RECOMMENDATION - 08/05/2019 14302 30TH AVE NE

SDCI PROJECT NUMBER

#3023581

8.0 ITEMIZED RESPONSE TO EDG: WRITTEN NARRATIVE

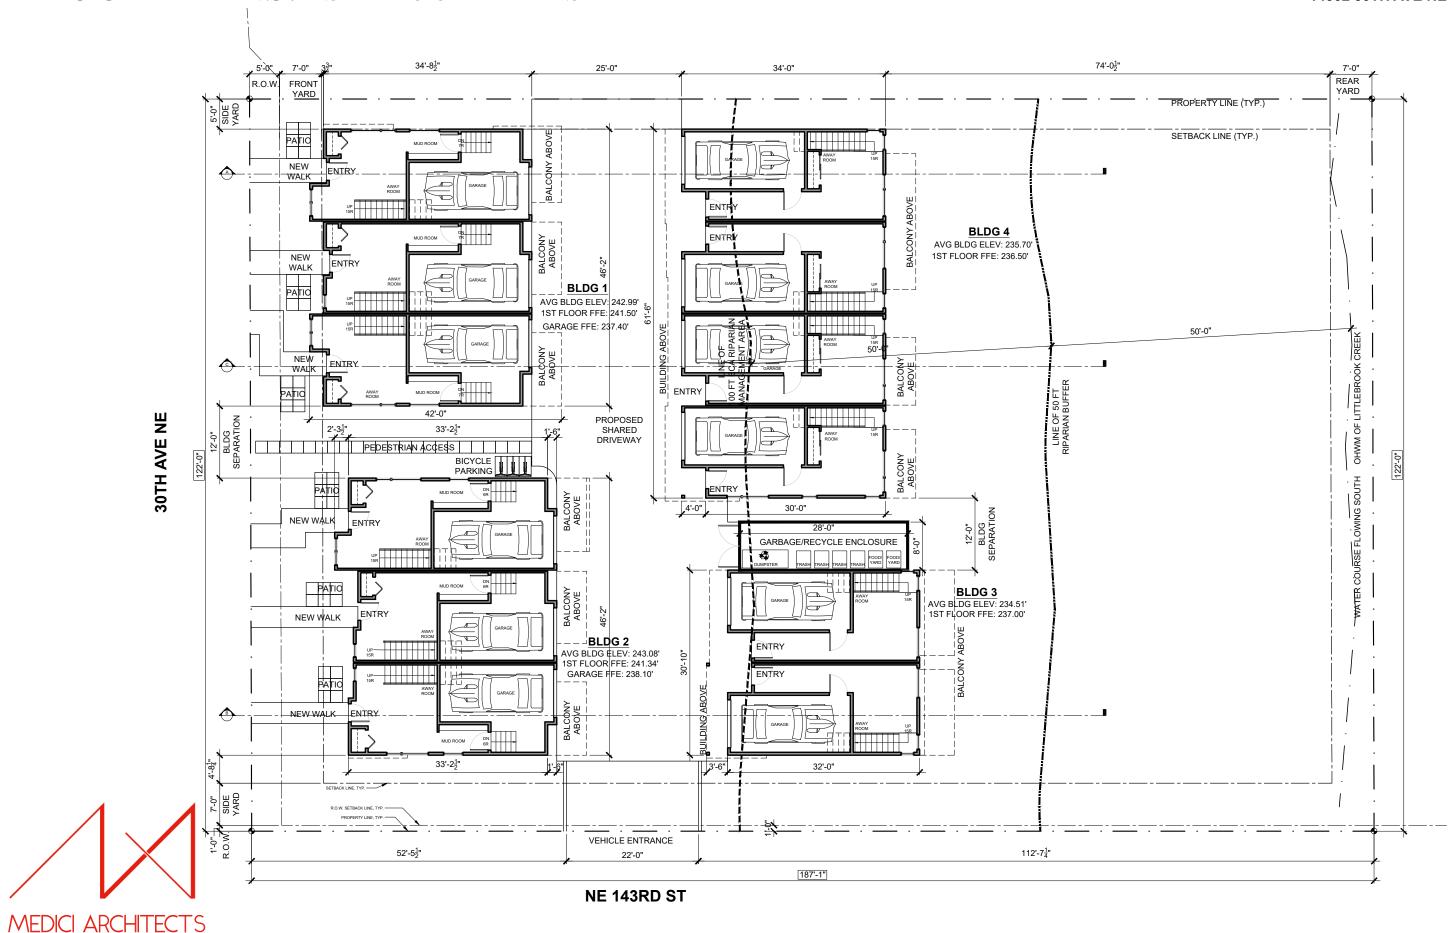
The Board was generally supportive of the preferred massing option (Scheme Three) but wanted the design team to explore a less flat or urban roof line approach for more of residential style a pitched roof approach while still allowing access to the rooftop spaces. The Board heard public comment about neighborhood character and felt that a pitched or sloped roof form would better fit with the adjacent single family residential structures. Further the Board was interested in seeing more of an innovative approach to the overall design focusing possibly on less symmetrical design forms. (CS2-D.3, CS2-D.4, CS3-A, DC2-C.3)

The Board was not in total agreement with the placement of the trash enclosure at the main entry near the corner of 30th Ave NE and NE 143 St. Members felt that the enclosure should either be located away from pedestrian areas to a less visible portion of the site to reduce impacts to the building's visual character, possibly tucked into the hillside or hammer head on the north side of the driveway aisle or better integrated into the building design. At the recommendation phase, the Board would like to see a fully developed waste management plan which identifies the placement and design of the trash enclosure especially in relationship to the windows and entry of the closest living unit. (DC1-C-4)

The Board was in support of the approach to preserving the riparian management buffer area to the east as a trade-off for supporting the total number of units, 12, instead of a reduced number but wanted to see how the site could be developed into a quasi-public space with the inclusion of a boardwalk or other amenities. The pathway would be a great public amenity while aiding in reducing impacts to what City GIS layers have identified as an ECA Riparian preserve. This area is to be re-vegetated with native plants and trees and Corridor and an ECA Wetland area. The Board wanted to see further details of the planting palette in terms of sizes, species, etc., and wanted to see a larger scaled drawings at the Recommendation meeting. (CS1-D, CS1-E, CS2-B)

The Board acknowledged public comment and wanted to make sure that the driveway court is wide enough for cars to gain access into the garages. Members felt that if a larger width for driveway proved to be necessary, then the setback for the units on the west side should be reduced. The Board asked for diagrams that demonstrate the viability of the garages and driveways. There was concern about fire access however and suggested that they might include an emergency access walkway along the northern property line in lieu of a fire department hammer head or turn around. Board members suggested that the applicant get the Fire Departments feedback on what will be required in terms of access. (CS2-B.2.)

Board members were concerned about the safety conditions of a corner site and suggested that the project would need to be well lit, with eyes on the creek area along with other safety features. Members suggested that if there is a board walk feature then it should be lit with safety in mind. (PL2-B.1, PL3-C.1, PL2-B.2, DC4-C)

Echoing public comment the Board wanted to see the use of warmer tones that are more muted rather than bright 'overwhelming 'colors but were also supportive of flashes or hints of color on specific elements like doors etc. Members were in support of the use of wood with the warm tones rather than the cool grays that are often used in the area and suggested that greens and earth-tones could work as a base color that might go well with the wood. (DC2-B.1, DC2-C.1, DC2-C.3, DC4-A)

Medici Response: The overall form of the buildings were altered to reflect a more North West contemporary silhouette with pitched roof forms and individualized modulation.

Medici Response: The placement of the garbage/recycling location was moved between buildings mid-lot to help screen it from pedestrian areas. The proposed location fulfills Waste Management Standards and was coordinated with Seattle Public Utilities.

Medici Response: Due to the nature of the Riparian Buffer from the

Little Brook Creek, the East 50'-0" of the lot was put aside as a nature

and their guests. See Landscape Plan. Medici Response: The driveway width is 25'-0", enough room for twoway traffic and access to individual garages. A central public pedestrian access has been included in the design that connects all units to 30th Ave

protected from public use. The next 50'-0" of Riparian Management Area

shall incorporate a cedar bark walking trail for the public use of residents

Medici Response: The design incorporated a warmer palette centering around blues, greens and natural wood tones. Pops of color are located at entry doors to individualize and highlight each residence entry.

Medici Response: The project will be well lit where pedestrian access enters the site, around entry and garage doors and vehicle entrances. Balconies were designed to overlook the Riparian Corridor; promoting a sense of natural surveillance.
